**SUBJECT: U.S. NUCLEAR REGULATORY COMMISSION REVIEW OF HOMESTAKE MINING COMPANY OF CALIFORNIA'S REQUEST TO START POST-CLOSURE MONITORING FOR THE WESTERN PORTION OF THE NORTH-OFFSITE AREA DATED 15 AUGUST 2017, DOCKET NO. 040-08903, LICENSE NO. SUA-1471**

U.S. NUCLEAR REGULATORY COMMISSION STAFF  
TECHNICAL EVALUATION REPORT

SUBJECT: Request to Start Post-Closure Monitoring for the Western Portion  
of the North-Offsite Area

Figure 2. Alluvial Aquifer Compliance Monitoring Well Locations (adapted from HMC's Groundwater Monitoring Plan License Amendment Request)

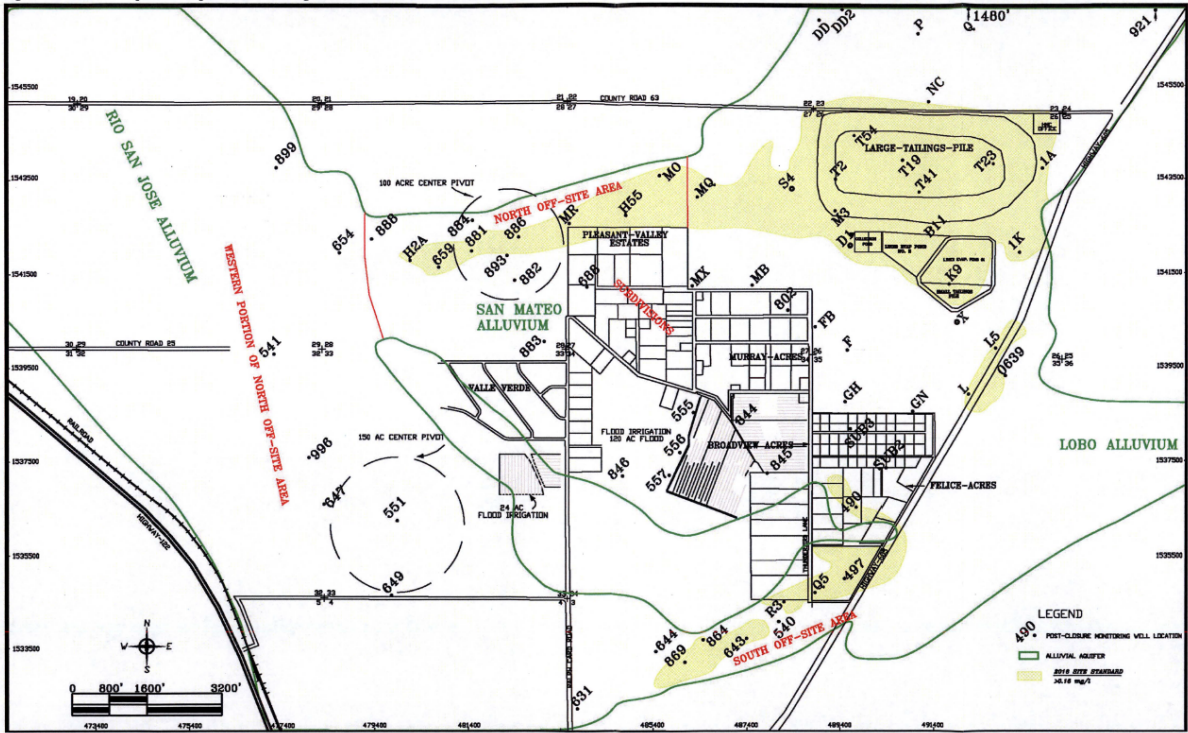
As shown in Figure 2 below, which was adapted from HMC's Groundwater Monitoring Plan LAR dated November 20, 2017, the seven wells proposed by HMC for post-closure monitoring are the compliance monitoring wells for the western portion of the North-Offsite area shown in the Groundwater Monitoring Plan LAR. The Groundwater Monitoring Plan LAR was approved by the NRC by license amendment dated November 12, 2019.<sup>9</sup> Although these wells currently meet the groundwater protection standards for uranium (i.e., <0.16 mg/L) and other constituents of concern, the NRC, in coordination with the Agencies, are unable to determine that these concentrations are representative of steady-state conditions and that the corrective actions have been fully effective. The injection wells and lines, shown in green in Figure 3 below, could result in dilution downgradient as the collection wells may not capture all of the injectate, which consists of reverse osmosis and zeolite treated-water and fresh water from the San Andres Glorieta aquifer. Therefore, the observed concentrations in this monitoring area might not be representative of the long-term state of the alluvial groundwater in the western portion of the North-Offsite area. Additionally, a Groundwater Corrective Action Plan (GCAP) LAR for the Grants site was submitted to the NRC for review and approval on December 18, 2019.<sup>10</sup> Initial review of the GCAP shows corrective actions at the Grants site extending into 2035 for final completion. Lastly, EPA, under its authority of the Comprehensive Environmental Response, Compensation, and Liability Act (CERCLA), is currently reassessing background and the groundwater protection standards approved by the NRC as part of the ongoing CERCLA remedial investigation and feasibility study equivalency analysis process being performed by the Licensee. If the groundwater remediation goals to be established by EPA in a future record of decision are below the currently approved NRC standards, then additional groundwater remediation may be required to achieve such CERCLA remediation goals in the western portion of the North-Offsite area. Accordingly, the NRC, in coordination with the Agencies, have determined that it is premature to start post-closure monitoring for the western portion of the North-Offsite area.
